2.5 Geology, Seismology, and Geotechnical Engineering

This Safety Evaluation Report (SER), written by NRC staff, is divided into five main parts (SER Sections 2.5.1 through 2.5.5) that parallel the five FSAR sections prepared by the applicant for the STP COL application. The discussion that follows presents the staff’s safety evaluation of the geology, seismology, and geotechnical engineering for the proposed STP Units 3 and 4.

Figure 2.5.1-5. Map of Growth Fault Projections, Lineaments, and Topographic Survey Points Within the STP Site Area (Reproduced from FSAR Figure 2.5S.1-45)

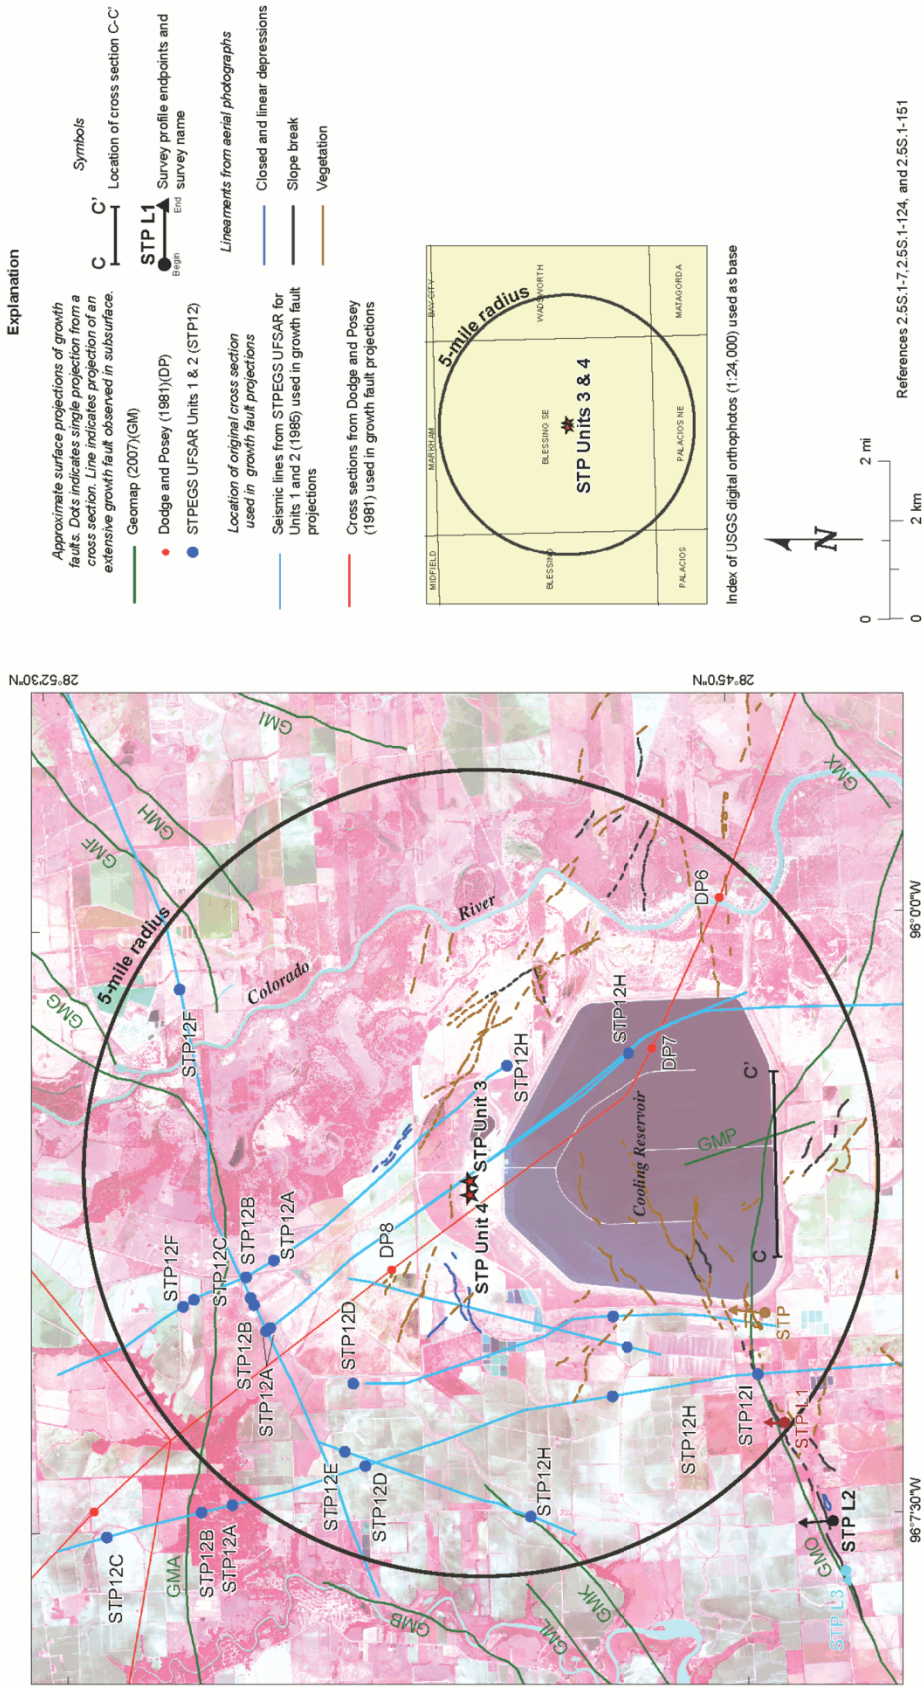
Given that seismic reflection, well log, and imagery data sources described in FSAR Subsection 2.5S.1.2.4.2.2 could not resolve surface locations of growth faults in the STP site area, the staff issued **RAI 02.05.01-8** requesting the applicant to explain why the investigations for the STP COL application site do not include a light detection and ranging (LiDAR) survey of the site area to reassess evidence for possible subtle surface folding or faulting along growth faults. The applicant's response to **RAI 02.05.01-8** dated July 16, 2008 (ML082030326), updates FSAR Figures 2.5S.1-44 and 2.5S.1-45 to include the locations of all "anomalous geomorphic features" that might indicate surficial deformation due to growth faulting. The applicant states that growth fault Matagorda STP12I (Matagorda GMO) is the only growth fault that could be correlated with linear geomorphic features identified in the applicant's aerial photographic analysis. Therefore, it is "the only fault within the site area with a geomorphic expression of potential Quaternary activity." With regard to applying other methods such as the LiDAR to investigate potential surface displacements, the applicant states the following:

The staff issued multiple RAIs related to the applicant's evaluation of growth fault Matagorda STP12I (Matagorda GMO). In **RAI 02.05.01-9**, the staff asked the applicant (1) to explain why the evaluation only measured the topographic offset at four locations along the surface projection of growth fault Matagorda STP12I (Matagorda GMO); and (2) to discuss the uncertainties in projecting this growth fault to the surface. The applicant's response to **RAI 02.05.01-9** dated October 1, 2008, states that the locations of the topographic surveys (as shown in SER Figure 2.5.1-5) are based on evidence for monoclinial folding that the applicant observed during initial field reconnaissance studies. The applicant's survey did not extend beyond the westernmost observed folding but did include one location (STP L4) that was along strike with the folding and was the closest available location to the cooling reservoir. The applicant states that even though there are uncertainties in the projection of growth fault Matagorda STP12I (Matagorda GMO), the fact that the monoclinial folding is evident in three of the four survey profiles provides confidence in the applicant's "best estimate" projection of Matagorda STP12I (Matagorda GMO).

As presented in Subsection 2.5S.1.2.4.2.2 and apparent in Figure 2.5S. 1-45, the monoclinical folding, lineations, and surface projections associated with fault I/GMO are strongly correlated, suggesting that the diversity of methods used to identify growth faults with surface expression (e.g., ground reconnaissance, fault projections, aerial photo analysis) were robust and capable of identifying the surface expression of growth faults if present. The robust nature of these methods then provides confidence that the methods are capable of identifying surface deformation from growth faulting throughout the site area if it exists. Therefore, it was deemed unnecessary to conduct a separate LiDAR survey to identify surface deformation associated with growth faulting.

The staff reviewed the applicant's response to **RAI 02.05.01-8**, including enhanced FSAR Figures 2.5S.1-44 and 2.5S.1-45, and acknowledged that the applicant has adequately identified a range of geomorphic features using available satellite imagery and aerial photographic data. In addition, the staff noted that the applicant has performed additional investigations of potential surficial features as part of aerial and field reconnaissance efforts.

The staff reviewed the applicant's response to **RAI 02.05.01-9**. The staff concurred with the applicant's reasoning for selecting profile locations STP L1 through STP L4 based on the evidence for monoclinial folding at the surface and on the applicant's preferred surface projection for growth fault STP GMO. The applicant's response assumes that the surface projection of growth fault Matagorda STP12I (Matagorda GMO) bends to the southeast around the cooling reservoir (as shown in SER Figures 2.5.1-4 and 2.5.1-5) rather than through the reservoir.

Figure 2.5.2-7, Response Spectra from the sensitivity test and comparison to the site-specific SSE

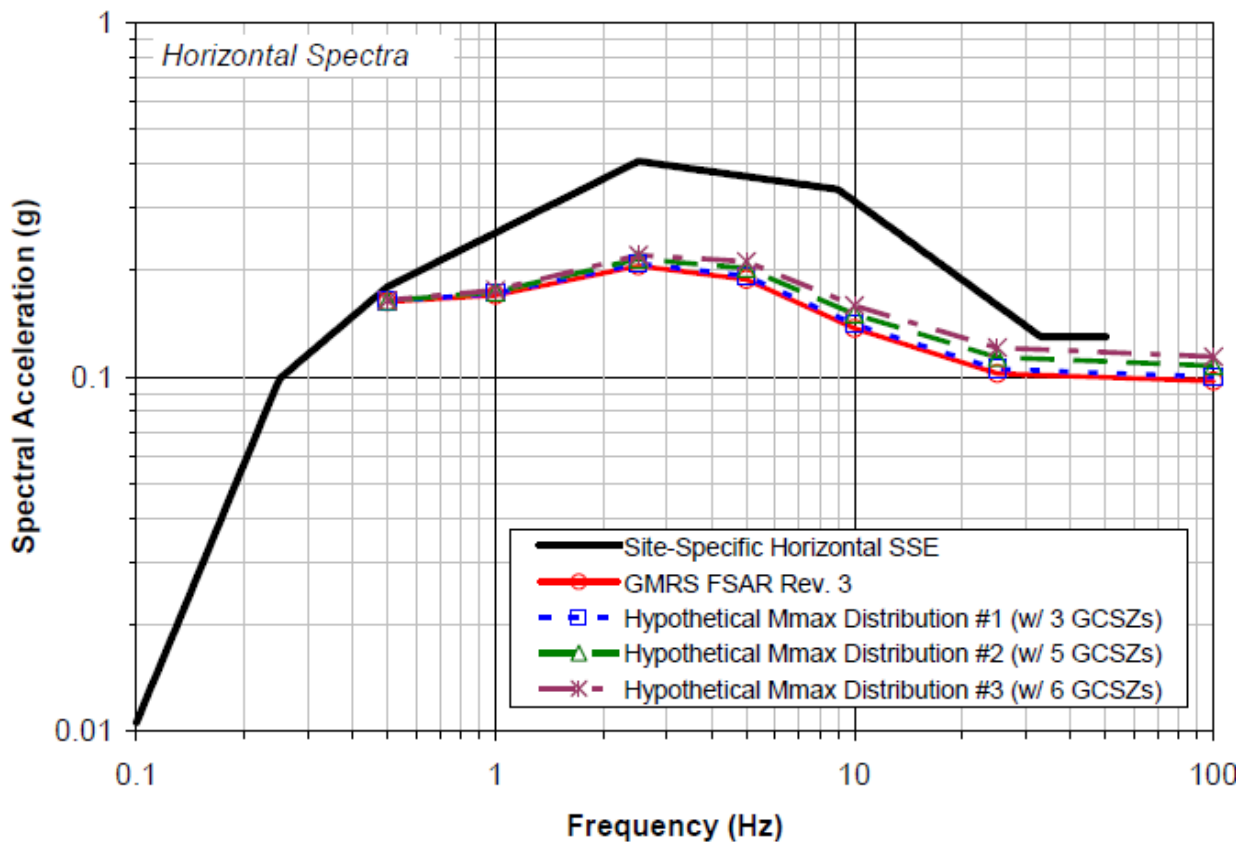
The results of the sensitivity study demonstrated that the increase in the GMRS at the STP site resulting from these three different scenarios ranged from 0% to 11%, with the exception of Scenario 3, which increased the GMRS by as much as 18% at a spectral frequency of 25 Hz. However, Scenario 3 includes an Mmax update to the Woodward Clyde B43 source zone, which is located very far from the two 2006 Gulf earthquakes (273 km (170 mi) and 635 km (395 mi)), and therefore, Scenario 3 is not considered plausible by the staff. The GMRS resulting from the three scenario Mmax updates are shown below in SER Figure 2.5.2-6.

Based on the results of the applicant's sensitivity study, the staff concluded that the higher Mmax distribution originally proposed by the TI team does not significantly increase the GMRS for the STP site. Under either Scenarios 1 or 2, the increase in the GMRS is only about 10% at most. This result can be attributed to the significant epicentral distances of the two 2006 Gulf earthquakes to the STP site as well as the relatively sparse seismicity with the Gulf. The SSHAC expert elicitation process specifies that the center, body, and range of the informed technical community should be represented when modeling seismic source zones for PSHA studies. Scenario 1 of the sensitivity study achieves this SSHAC goal better than either Scenarios 2 or 3, while simultaneously reaching an Mmax value of m_b 7.2 for four of the six ESTs. Under Scenario 1, the largest increase in the GMRS for the STP site is only 3%. For the actual maximum magnitude distributions adopted by the TI team, only the Law Engineering Source Zone-126 is somewhat low (m_b 5.5 [0.9], 5.7 [0.1]); however, this source zone does not include either of the two 2006 Gulf Coast earthquakes.

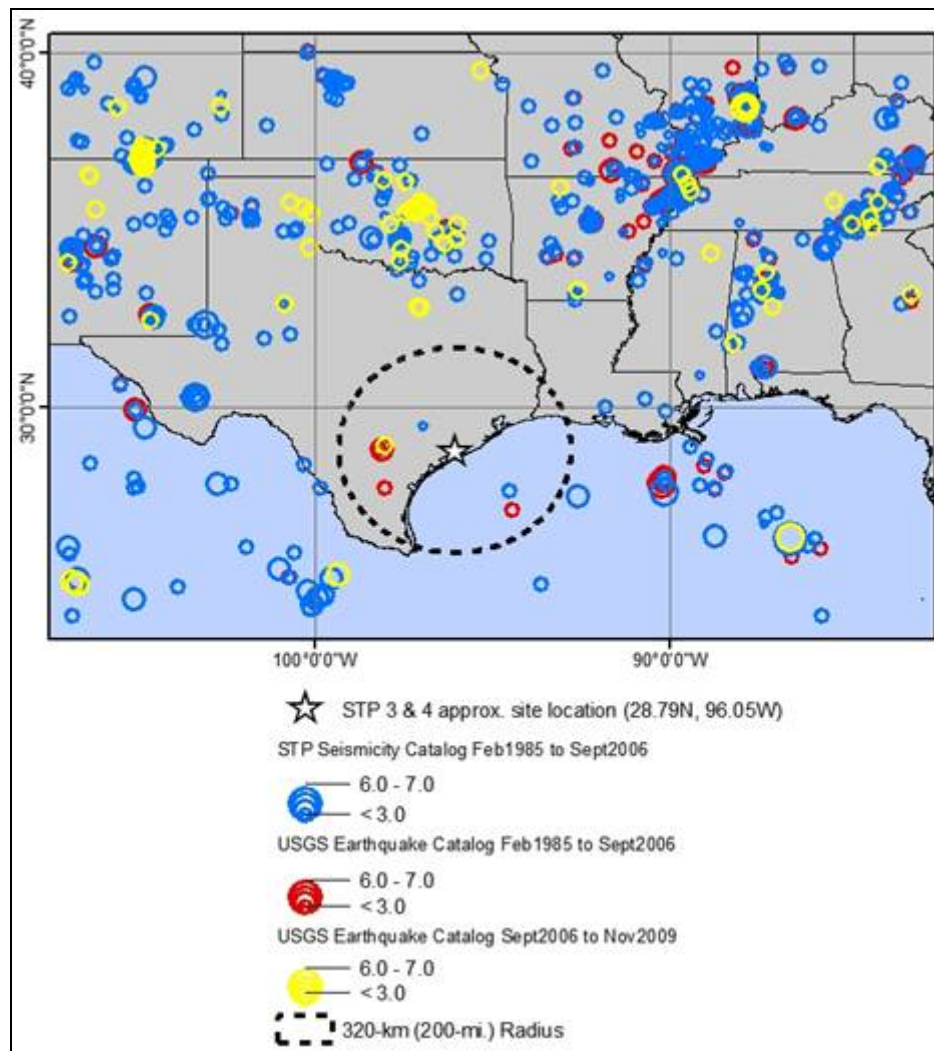
Based on the spatial distribution of earthquakes in the updated catalog, NRC staff concurred with the applicant's conclusion that significant revisions to the existing EPRI-SOG source geometries are not warranted. The staff's review evaluated the completeness of the applicant's updated earthquake catalog and the applicant's subsequent conclusions, by comparing the applicant's earthquake catalog to a compilation catalog derived from the USGS seismicity catalogs. The catalog data from February 1985 to September 2006 are depicted in SER Figure 2.5.2.6 as the red circles. The applicant's updated seismicity catalog is illustrated by the blue circles, which cover February 1985 to September 2006. The comparison of these data sets illustrates that the applicant's updated earthquake catalog adequately characterizes the

any significant seismicity since 2006 that would change the applicant's conclusions. The yellow circles in SER Figure 2.5.2-6 illustrate the seismicity documented in the USGS catalog from September 2006 through November 2009. This recent seismicity does not show any significant deviations from the applicant's seismicity catalogs.

Therefore, the staff concluded that the STP Units 3 and 4 earthquake catalog adequately characterizes regional and local seismicity through November 2009. In addition, the staff agreed that the spatial distribution of earthquakes in the region had not changed significantly since the publication of the EPRI-SOG earthquake catalog. The staff found that the applicant has adequately evaluated the potential for new seismic sources or for revisions to existing source geometries based on seismicity patterns. Therefore, the applicant meets the requirements of 10 CFR 52.79 and 10 CFR 100.23.

Figure 2.5.4-7. Site-Specific Sand Shear Modulus Curves Based on RCTS Testing (FSAR Figure 2.5S.4-62)

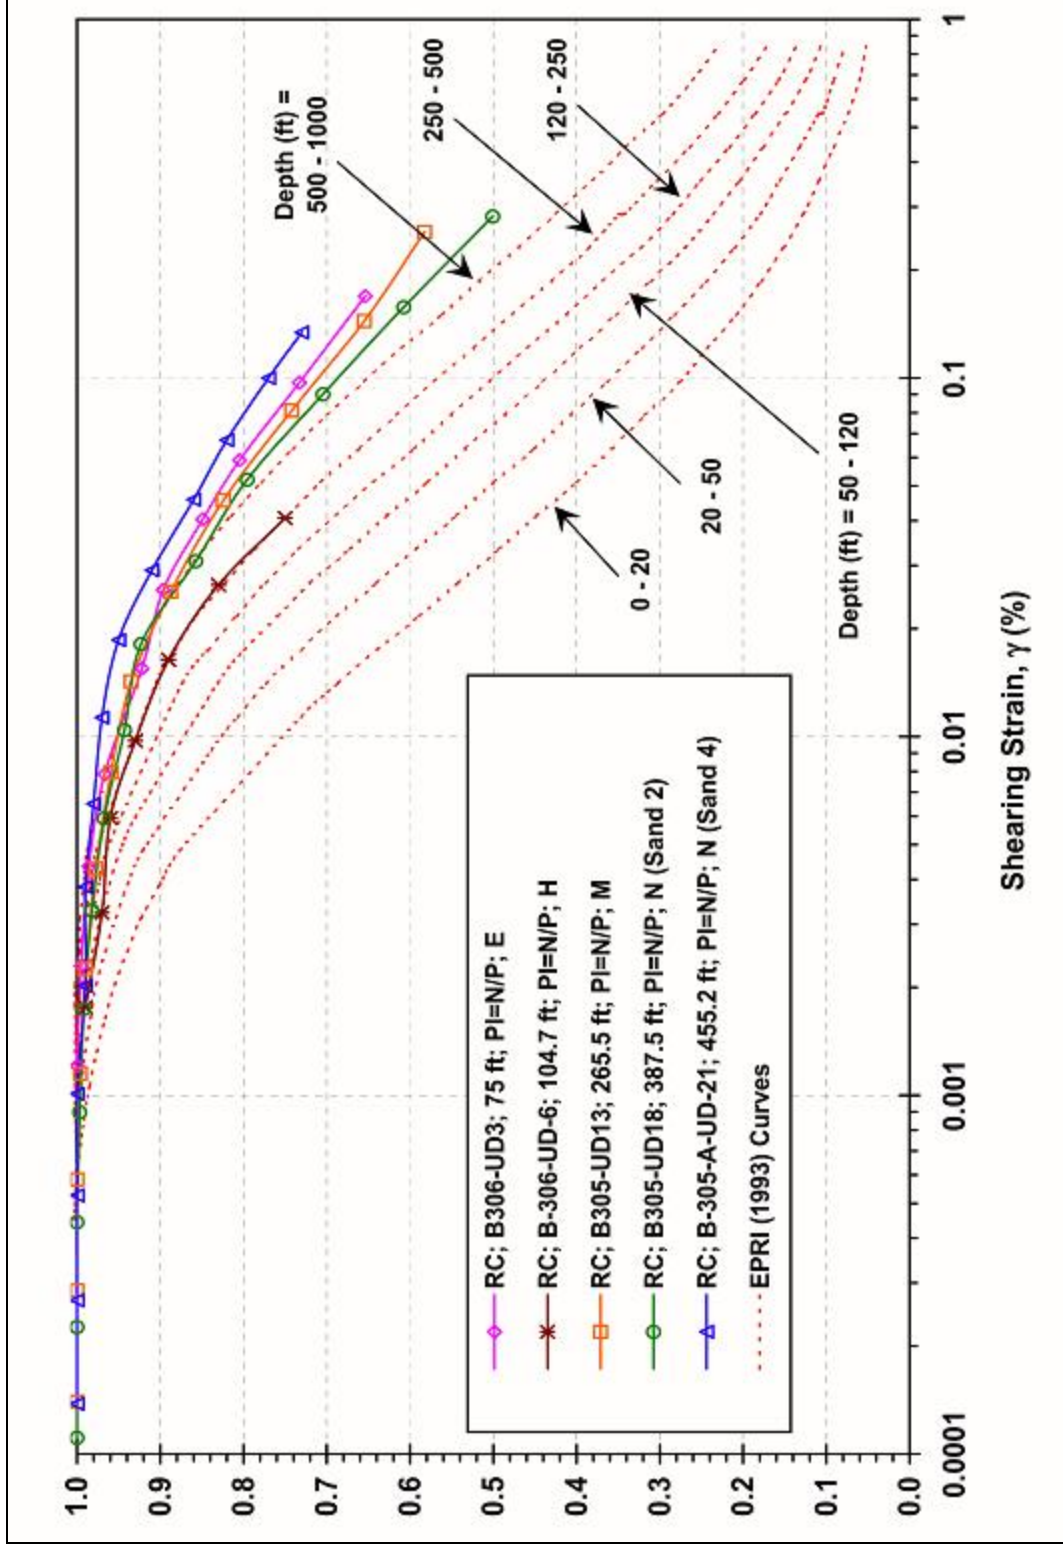
The applicant's response to **RAI 02.05.02-17** dated July 2, 2008 (ML081890239), revises the COL application to include additional RCTS testing in FSAR Subsection 2.5.4.7, which increases the total number of RCTS tests from five to sixteen. The applicant also presents in FSAR Figures 2.5S.4-62 through 2.5S.4-68 site-specific shear modulus and damping ratio curves developed for each stratum down to a depth of approximately 182.8 m (600 ft). The applicant demonstrates that the selected shear modulus and damping ratio versus strain relationships from the literature closely match the site-specific developed curves. Because the literature-based curves were carried out at higher strain levels than the site-specific curves, the applicant used the literature-based curves to calculate the GMRS. SER Figures 2.5.4-7 and 2.5.4-8 (FSAR Figures 2.5S.4-62 and 2.5S.4-66) compare the site-specific shear modulus and damping ratio curves performed on all sand stratum to the EPRI curves, respectively.

The staff reviewed the applicant's RCTS results and the comparisons to the literature-based curves presented in FSAR Figures 2.5S.4-62 through 2.5S.4-68. Except for the deep cohesionless soils in FSAR Figure 2.5S.4-63, the staff agreed with the applicant that the site-specific curves are bounded by the literature-based curves and selected the literature-based curves that best define the trend of the site-specific curves for use in computing the GMRS with one exception: the deep cohesionless soils in SER Figure 2.5.4-1 display a stiffer response than the EPRI curves. However, considering that the EPRI curve selected to represent the deep sand strata is not significantly different from the site-specific curves out to a strain of 0.1 percent, and the logarithmic mean maximum strain profiles in SER Figure 2.5.4-11 (FSAR Figure 2.5S.2-47) are typically significantly less than 0.1 percent strain, the staff concluded that the selected literature-based curves track well with the site-specific curves and are appropriate for determining the GMRS. Finally, the staff concluded that the characterization of the dynamic properties of the in-situ materials is complete, therefore, **RAI 02.05.02-17** is resolved.
